TRIP REPORT

VILLAGE SAFE WATER

LOCATION: Emmonak, Alaska **PROJECT NO:** N/A

PURPOSE: Inspect New Washeteria

Figure 6. Revised cross section for parking area fill pad embankment.

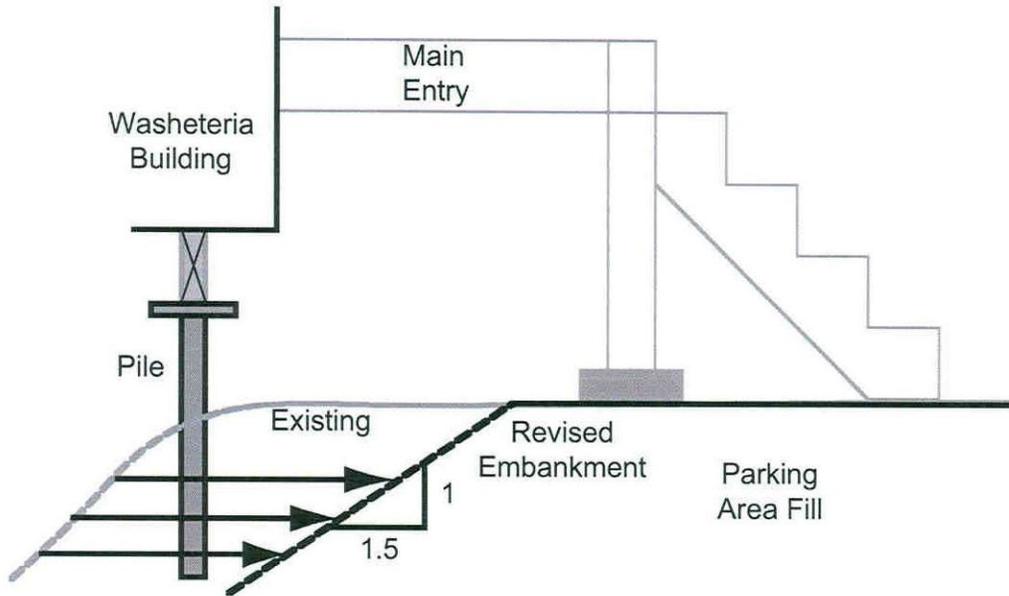
- Lower the existing grade below the utility enclosure by manually excavating material so that at least 6 inches of clearance is provided below the enclosure at all points. Care should be taken to maintain positive drainage so that surface water runoff does not collect underneath the enclosure or around nearby piles.
- Provide an allowance for seasonal movement of the water and sewer pipes. This may be accomplished either by locating the supporting timber cribbing further from the enclosure or designing flexibility into the pipe penetrations and connections inside the enclosure.
- Manually remove the loose cobbles and boulders from around all piles and cross bracing along the south side of the building so that future ground motion will not cause interference with the above grade support structure. Provide at least 6 inches of clearance under the cross bracing.

- Remove the parking area fill and loose rocks from around the pile supports and cross bracing along the north, east, and west sides of the building. Reestablish the fill pad such that the toe of the embankment does not extend to the piles under the building. The embankment shoulders should be sloped at 1.5 horizontal to 1 vertical (1.5:1) or flatter.

SITE LAYOUT and PHOTO KEY
New Washeteria Building
 Emmonak, Alaska

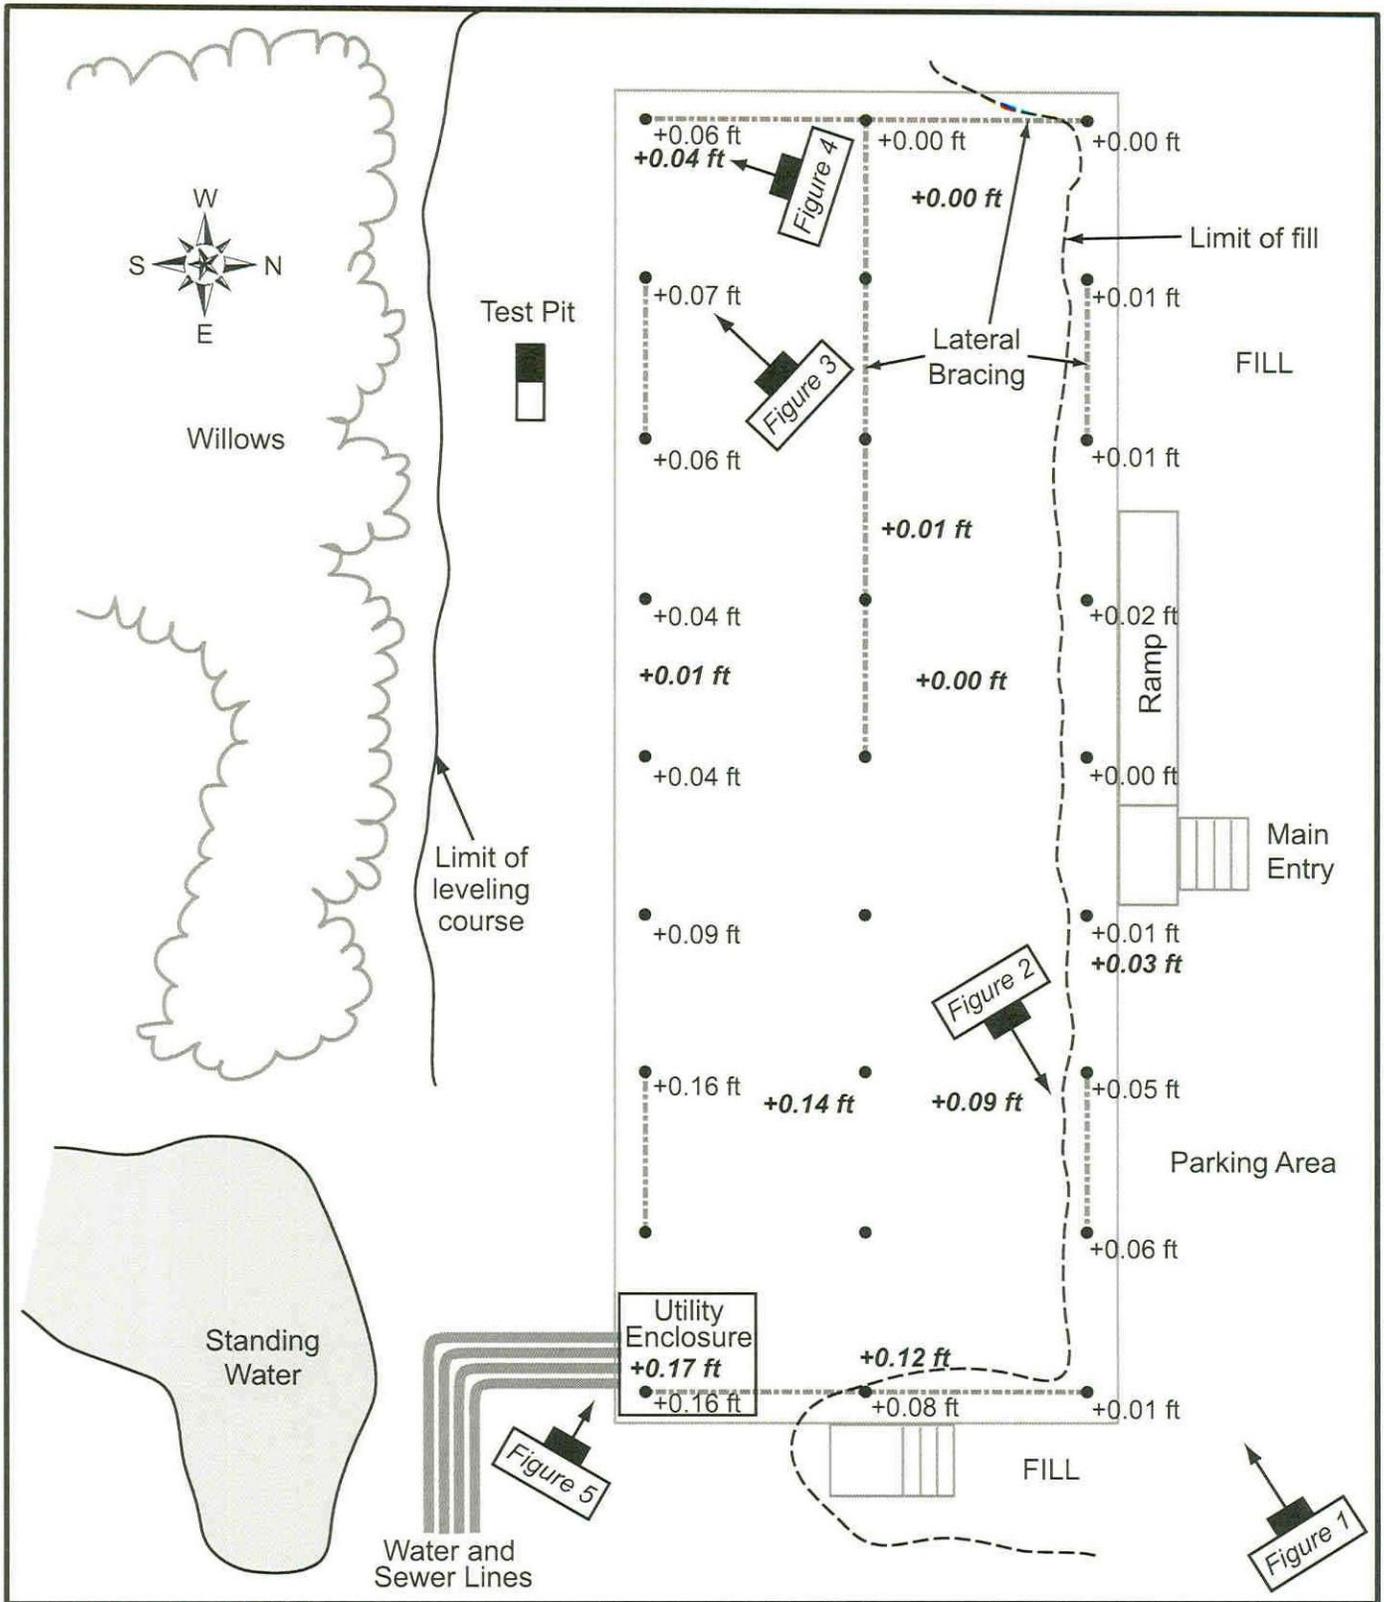
We measured relative levels of the bottom of the glulam beams around the perimeter of the building using an auto-leveling laser and detector. Relative

interior finish floor heights were also measured for comparison. Both surveys indicate the southeast corner of the building is approximately 2 inches higher than the rest of the building areas. The survey results are shown on Plate 1.
